DOCKETED	
Docket Number:	23-AFC-02
Project Title:	Elmore North Geothermal Project (ENGP)
TN #:	256155
Document Title:	Elmore North Geothermal LLC Responses to CURE Comments on the ICAPCD PDOC
Description:	N/A
Filer:	Lindsey Xayachack
Organization:	Jacobs
Submitter Role:	Applicant Consultant
Submission Date:	5/3/2024 9:17:31 AM
Docketed Date:	5/3/2024

RE: Selected Responses to the California Unions for Reliable Energy Comments on the Preliminary Decision to Grant a Preliminary Determination of Compliance for the Elmore North Geothermal Power Generation Plant

Figure IV.A.1-1
Comparison of Wind Roses
Elmore North Geothermal Project
Imperial County, California

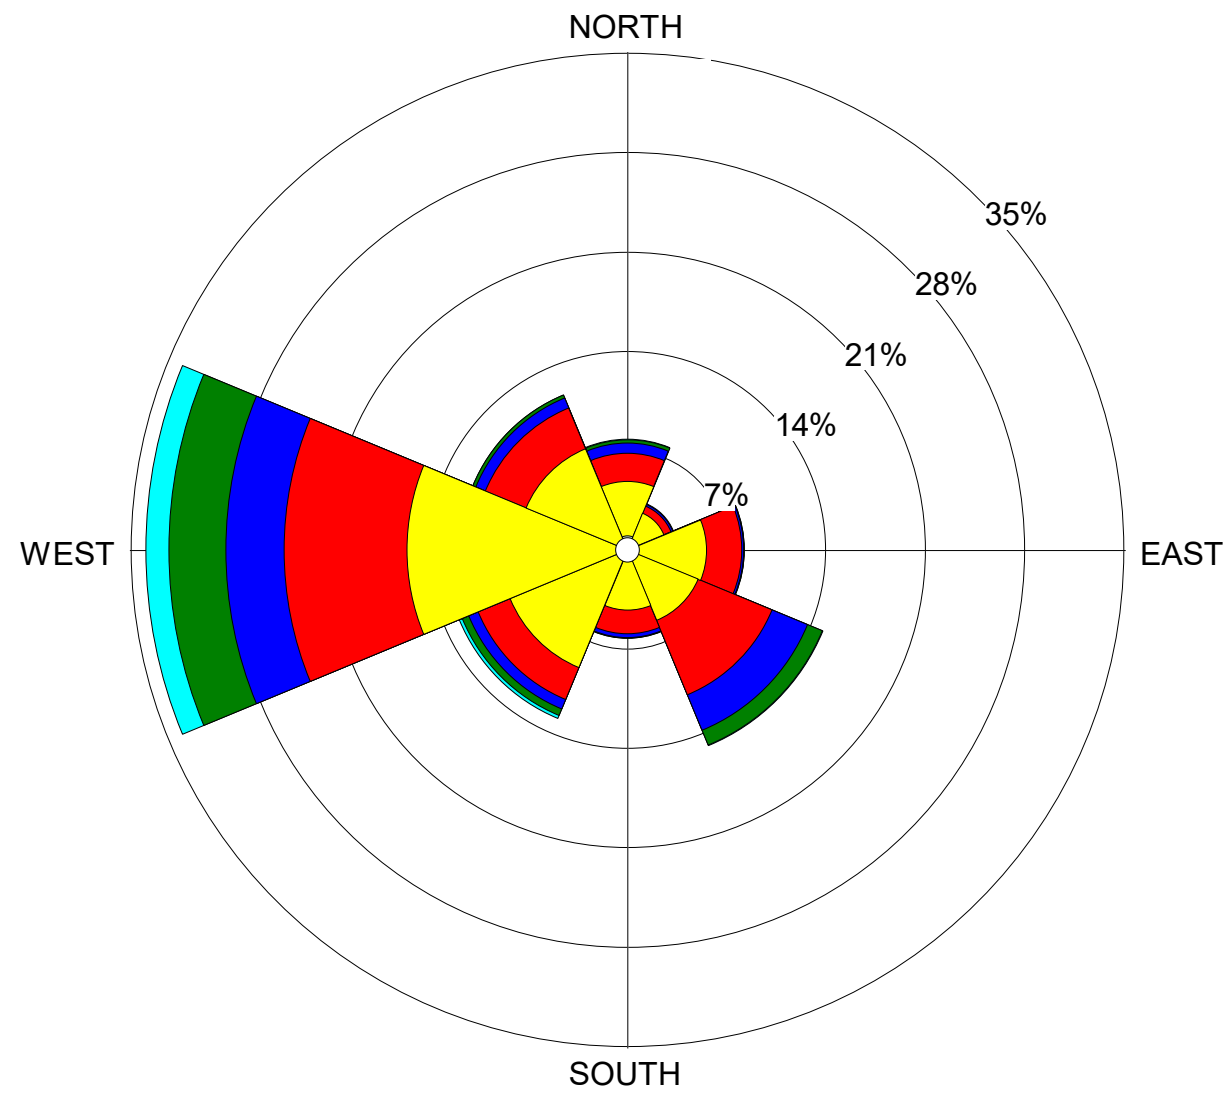
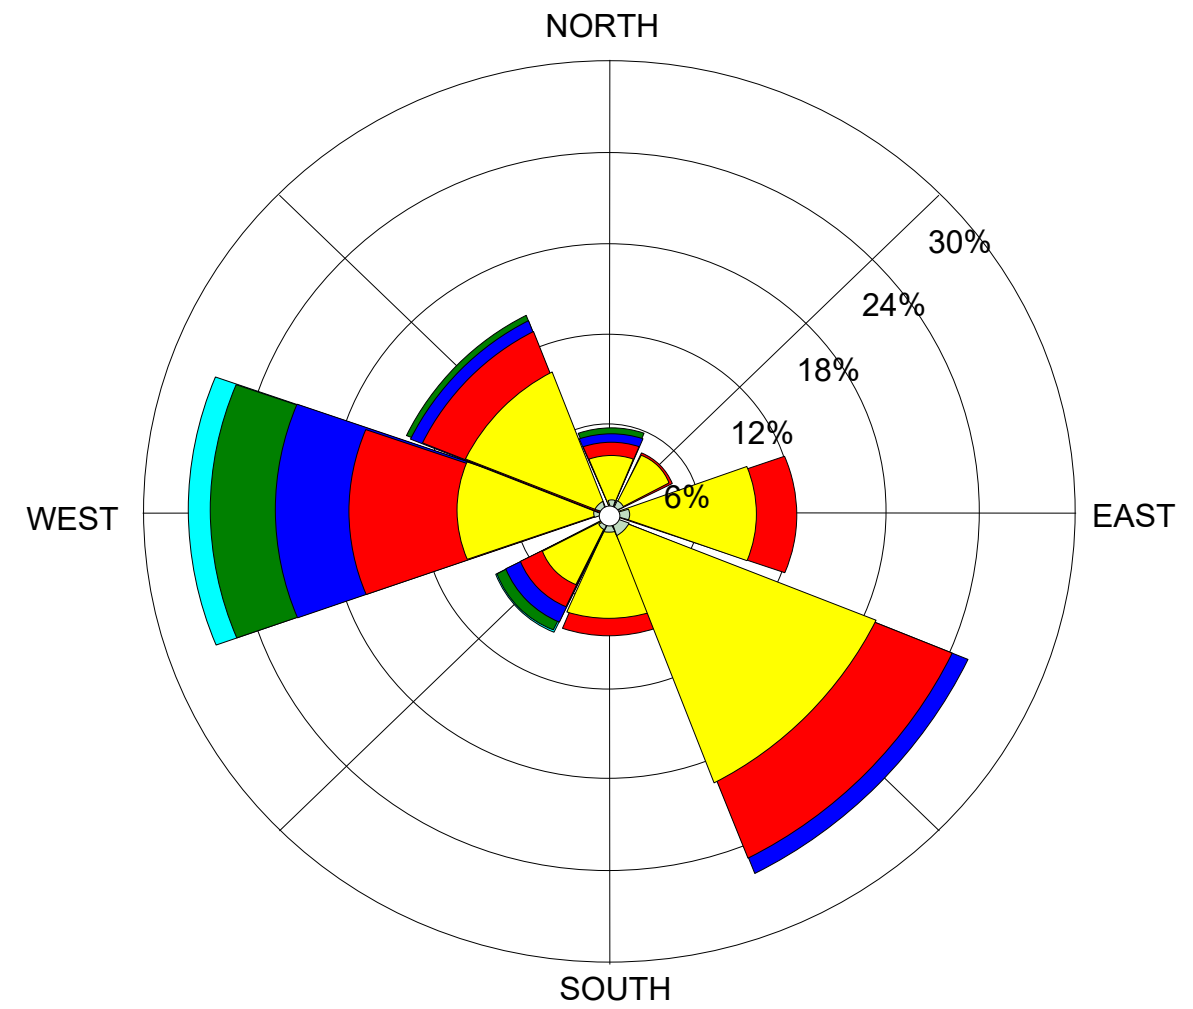
Lastly, although the Imperial County Airport is located over 28 miles from the project site, there are no significant geographic features between the two locations and both are located south/southeast of the Salton Sea. The lack of significant geographic features between the two locations is itself an indicator of representativeness of the Imperial County Airport meteorological data,⁶ but also leads to the expectation that wind speeds and wind directions in the project vicinity are similar to those incurred at the Imperial County Airport. This expected similarity is verified by comparing the wind rose for the Imperial County Airport (for years 2015 to 2018 and 2021) to the wind rose for the Sonny Bono monitoring station (for years 2020 to 2022). As shown in Figure IV.A.1-1, attached hereto, both wind roses share the predominant wind directions from the west and southeast.

Based on the above, the meteorological data collected at the Sonny Bono monitoring station is not more suitable for modeling as the data does not meet the minimum requirements for completeness, and would not be any more representative of the project site than the Imperial County Airport data based on a comparison of wind roses. Furthermore, as an ASOS station, the Imperial County Airport NWS station may provide fewer missing hours of wind speeds and wind directions. For these reasons, the Applicant supports the continued use of the Imperial County Airport NWS station meteorological data, as previously approved both by the ICAPCD and CEC.⁷
